CITY OF PORT LAVACA

SUBJECT: Animal Shelter renovations

Subject: B&R RFP-353-008 – Revision 1
Project Location: Port Lavaca Animal Control Center
Project Title: Renovations and Conversion of Kennel from Open Air to Enclosed Facility

Renovations and Additions to
Port Lavaca Animal Shelter
201 Stringham Port Lavaca, Texas 77979

POWER PLAN

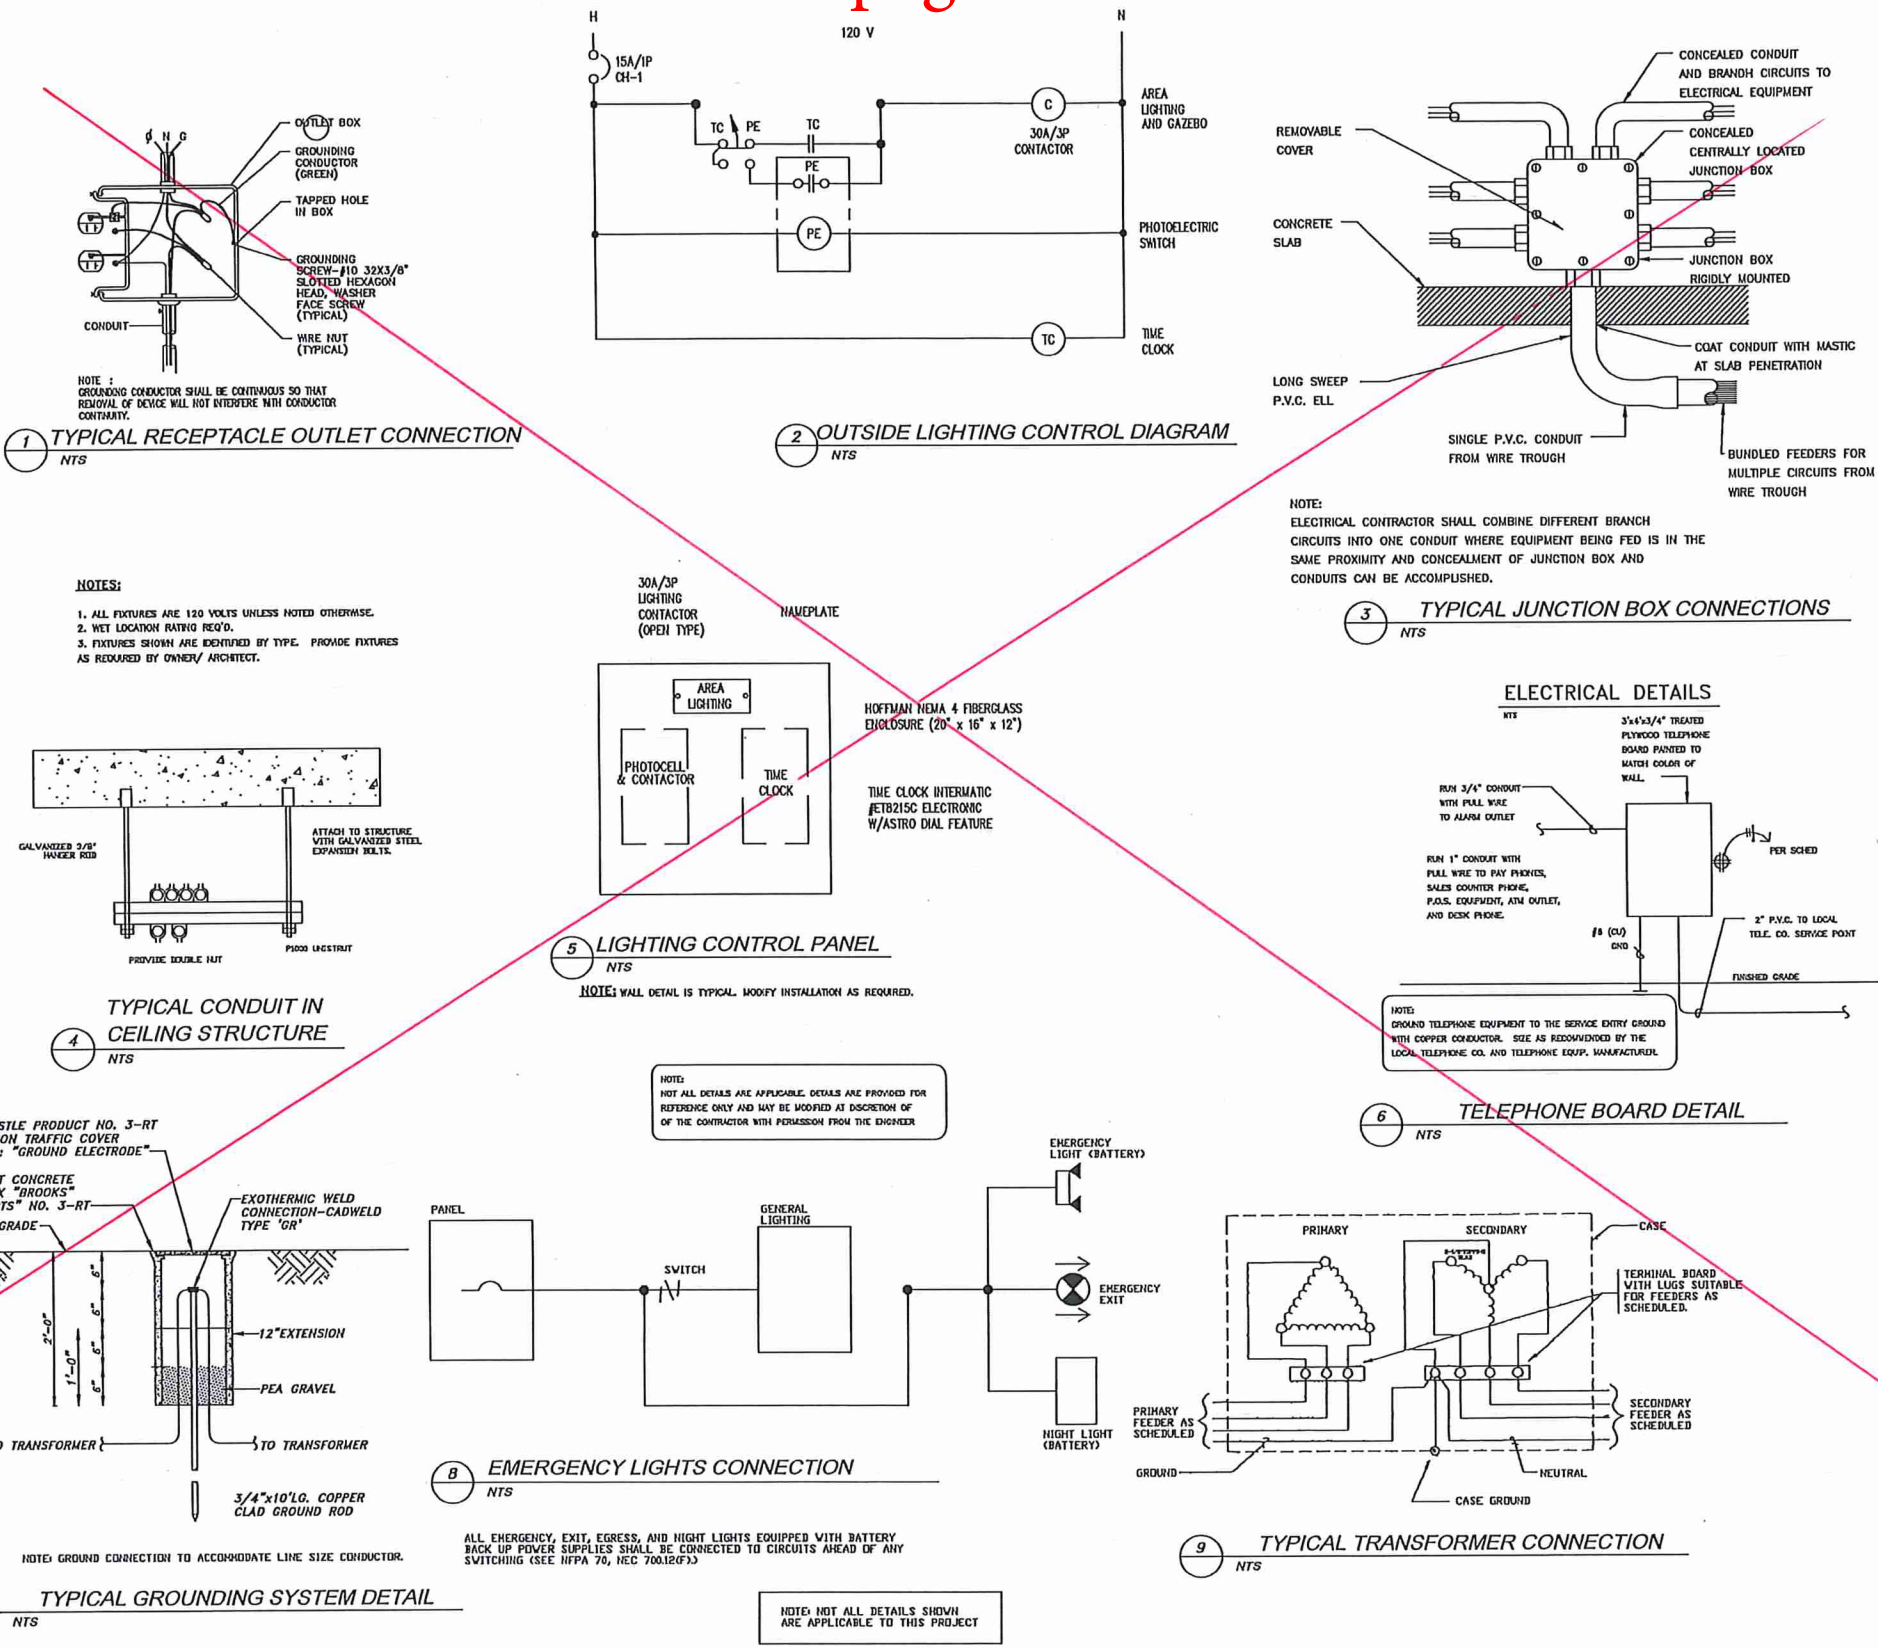
Delete page

PLUMBING
FLOOR PLANS

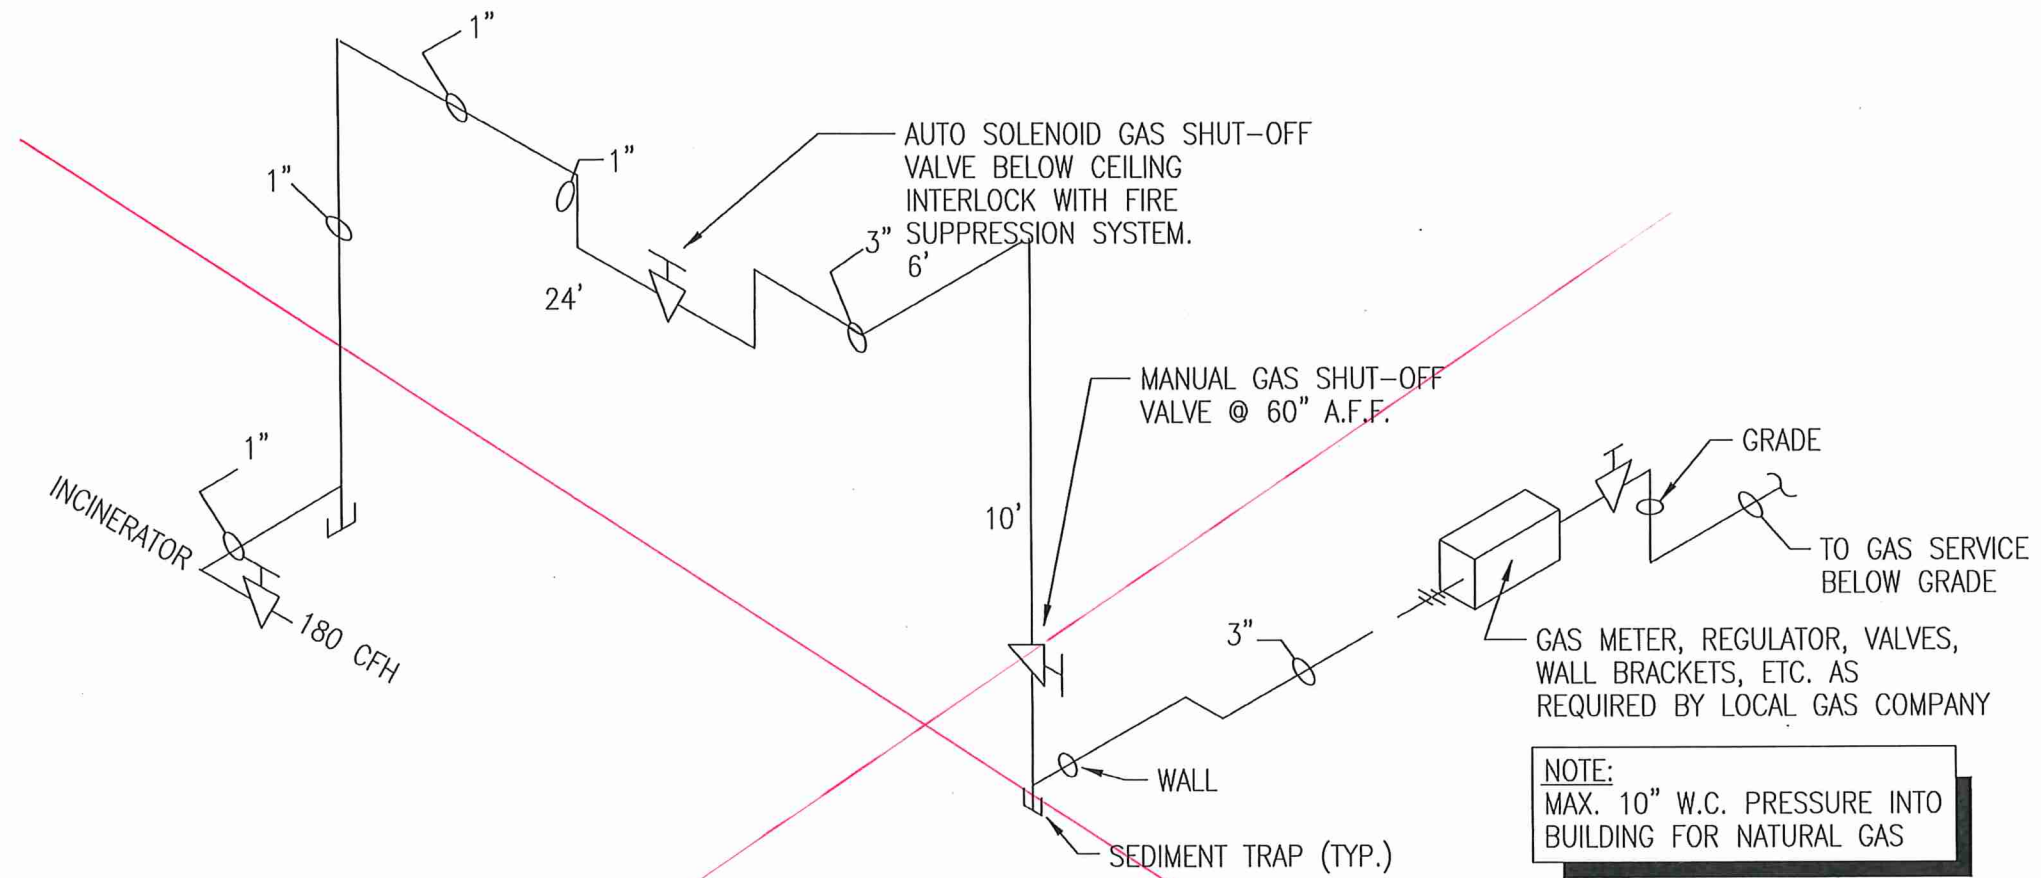
Delete page
GAS RISER
NTS
